Issue List

05-26-25 CAVA WARWICK, RI

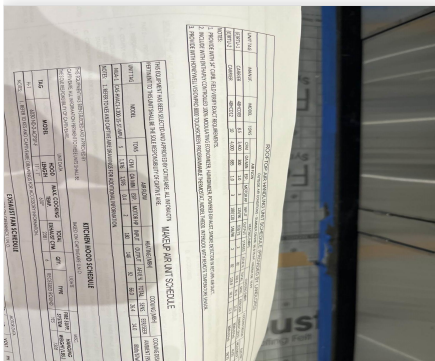
Issue Name : Hood "Core #01 Fault"
Description : The kitchen hood HMI is displaying "Core #01 Fault". This did not effect the balancing of the hood.
Created By : National TAB **Assigned To :** National TAB - Will Turnbough
Status : Open
Priority : InfoOnly **Asset Tag :**
Originated Date : 05/27/2025 - Stephen Tassinaro - National TAB

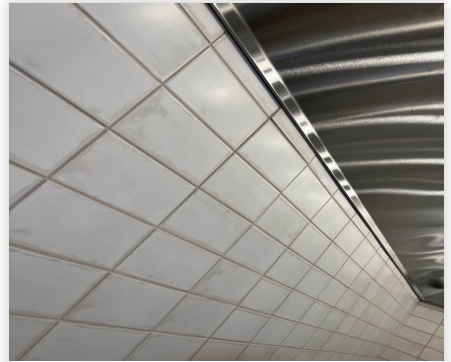
Issue Name : Kitchen Hood Not Caulked
Description : The kitchen hood should be caulked at all points in which it touches the wall to prevent grease accumulation.
Created By : National TAB **Assigned To :** National TAB - Will Turnbough
Status : Open
Priority : Low **Asset Tag :**
Originated Date : 05/28/2025 - Stephen Tassinaro - National TAB
